City of Portland, Maine – Building or Use Permit Application 389 Congress Street, 04101, Tel: (207) 874-8703, FAX: 874-8716

BUILDING PERMIT REPORT #26

DATE: 03 OCT. 2000 ADDRESS: LOT #5 Quiet Lane CBL: 388-B A-056
REASON FOR PERMIT: Single Family dwelling dwelling/attached private garage
BUILDING OWNER: Nan Sawyer
PERMIT APPLICANT: CONTRACTOR Chase Custom Homes
USE GROUP: R-3 CONSTRUCTION TYPE: 5B CONSTRUCTION COST: 265,000 PERMIT FEES: 1,914.00

**CITY OF PORTLAND, ME
BOCA 1999 Plan Review Record
One and Two Family Dwelling**

REAR ELEVATION

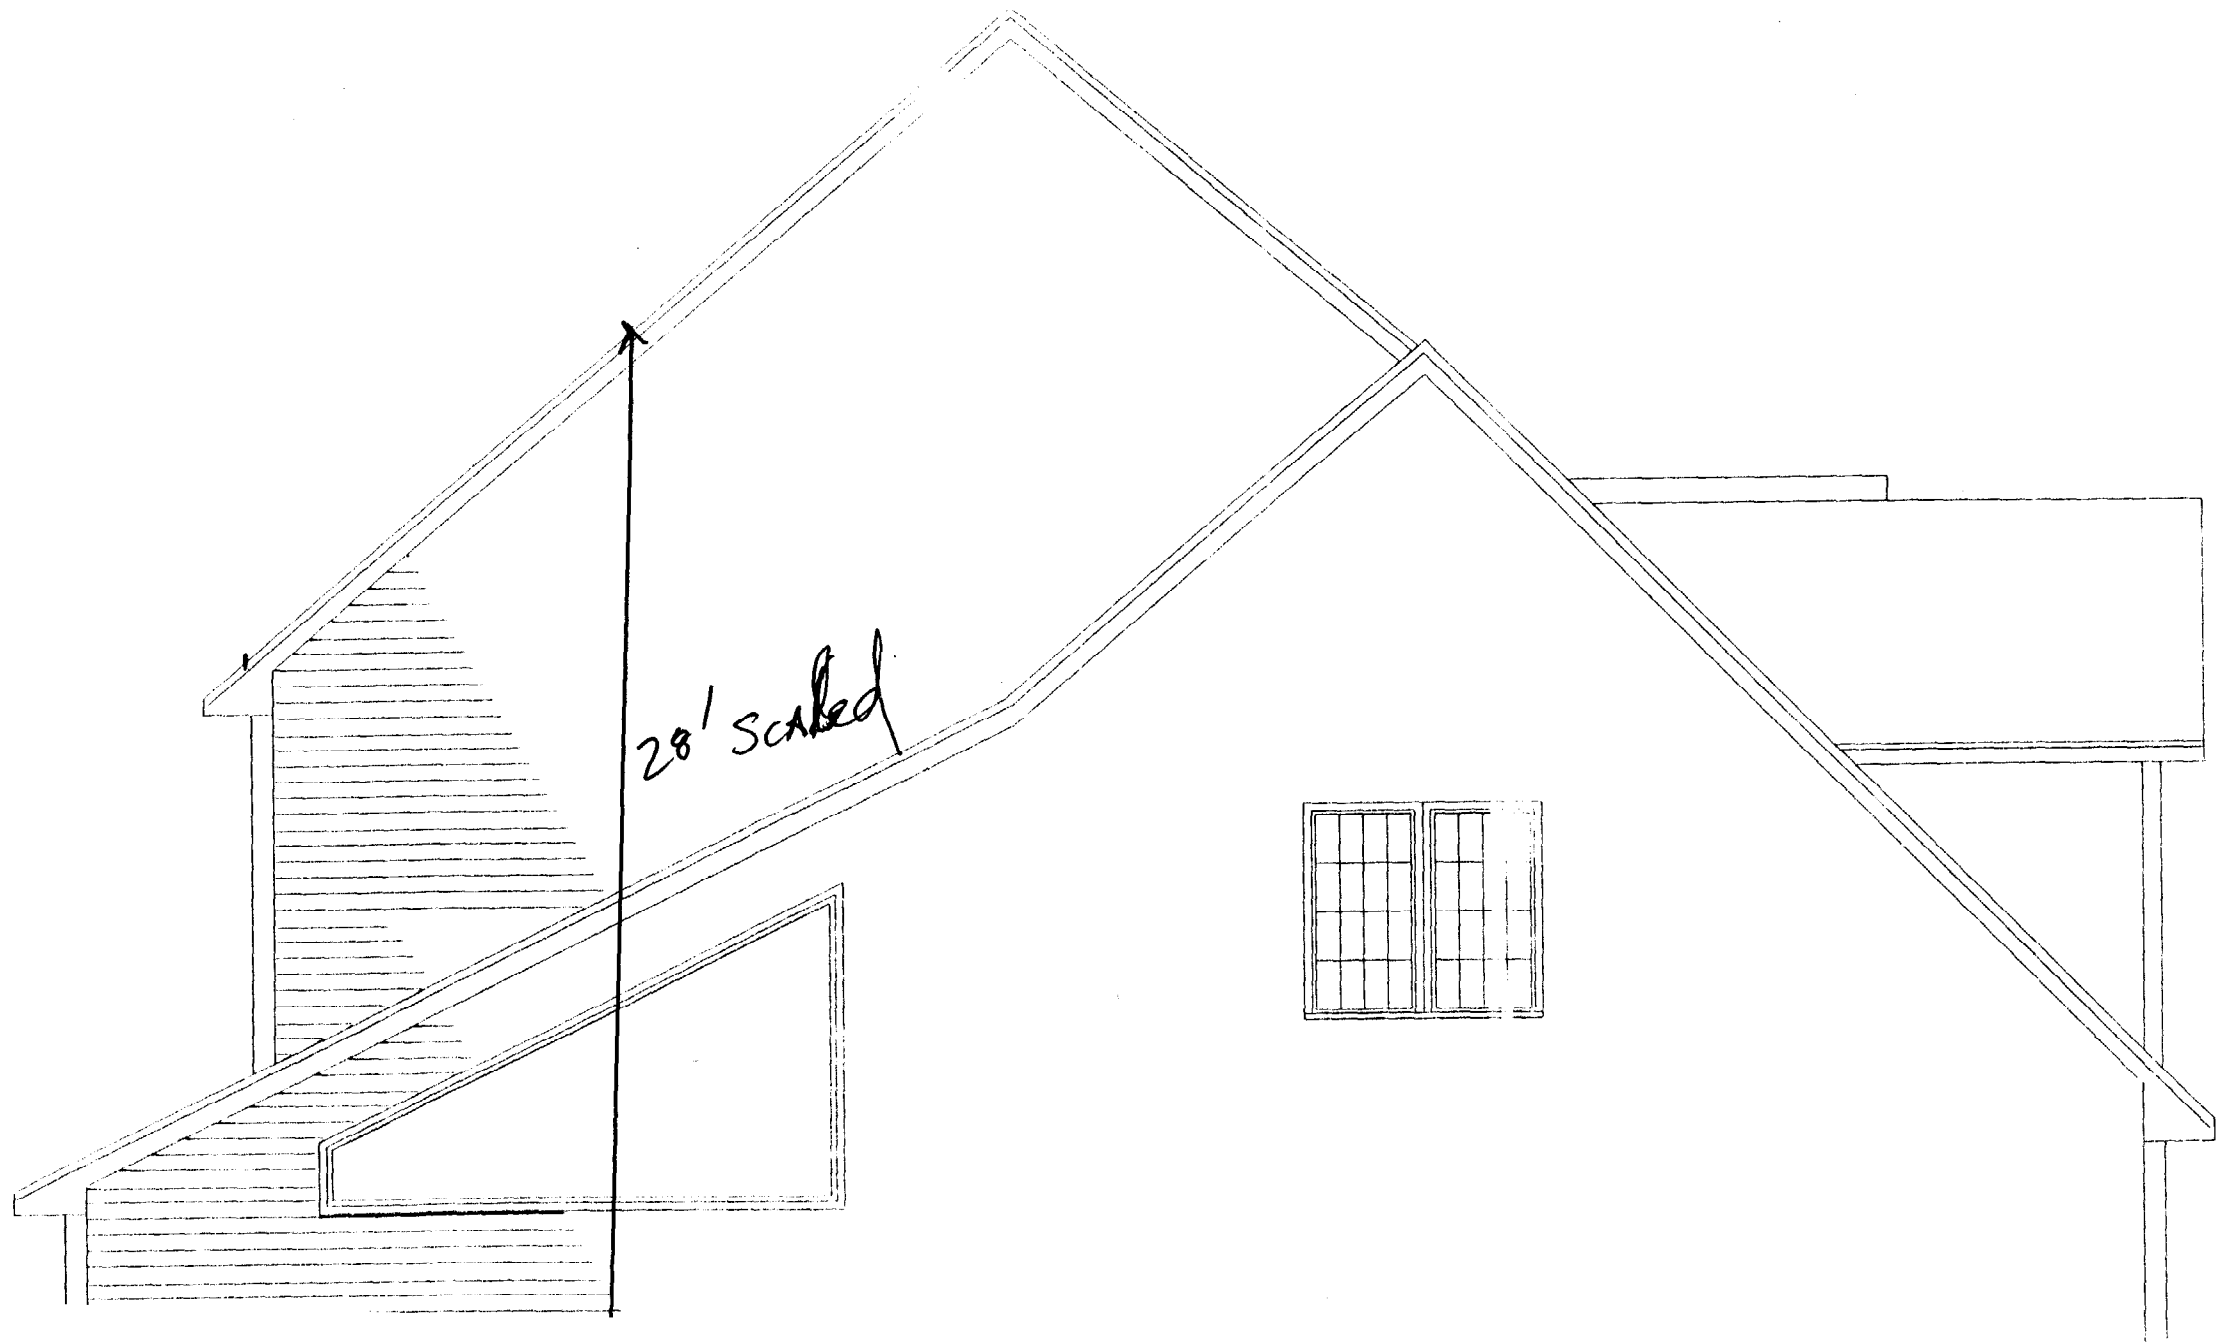
Not Approved
with the ~~plans~~ permit
-1 more a day

Not Approved
with the ~~plans~~ permit
No specifies shown
flat plan or structural plans

House is reversed from plot plan

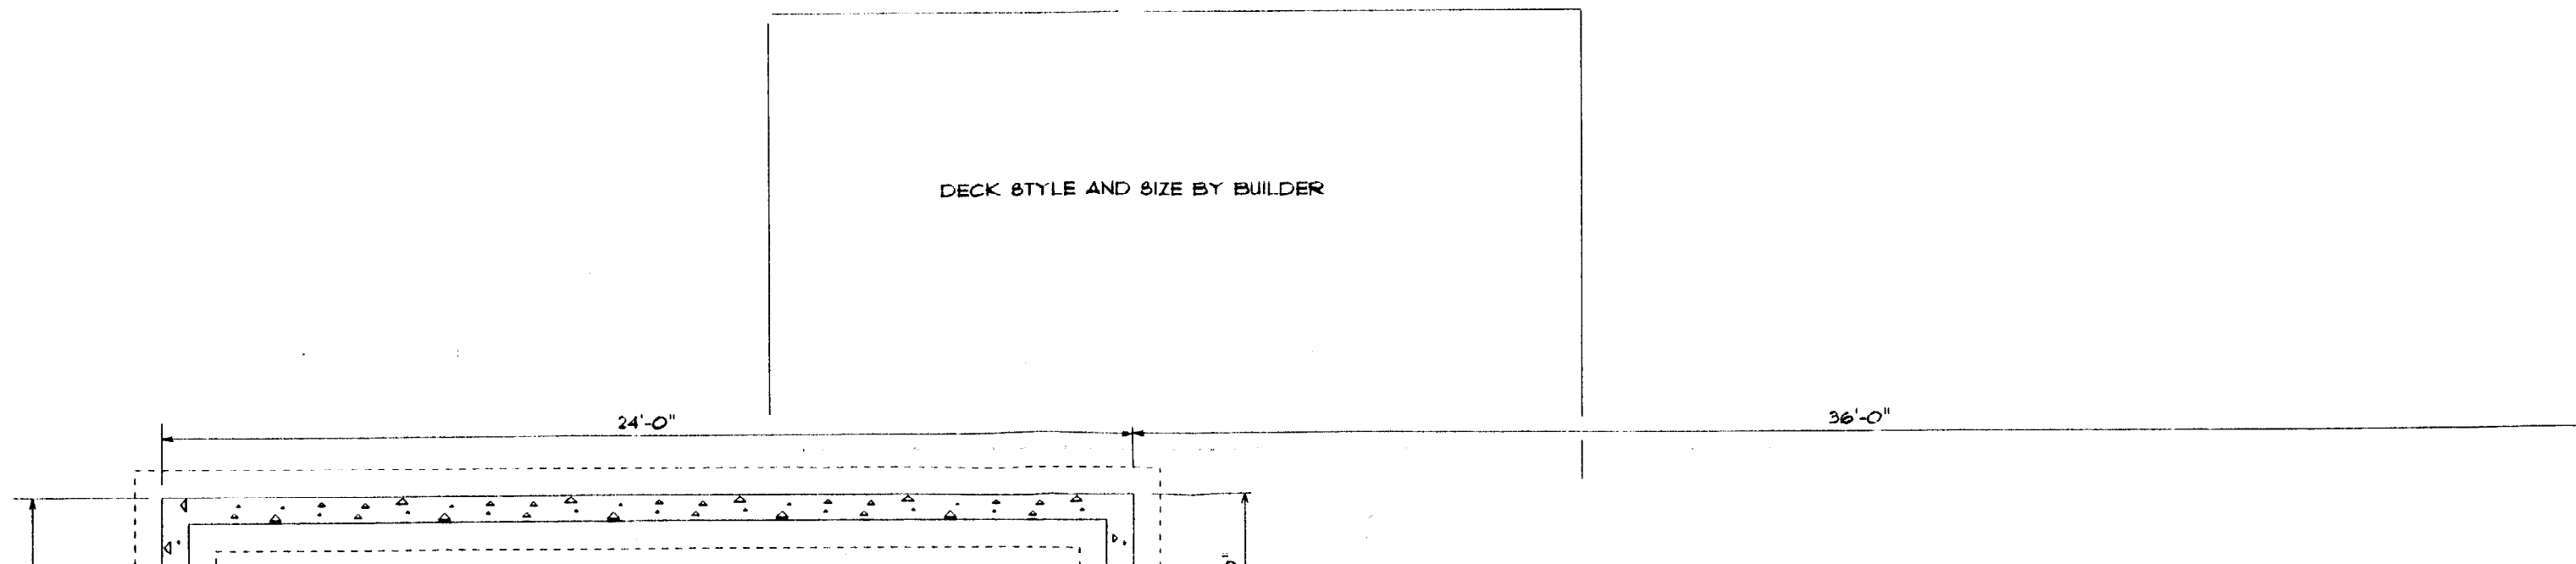
*None shown
so none permitted*
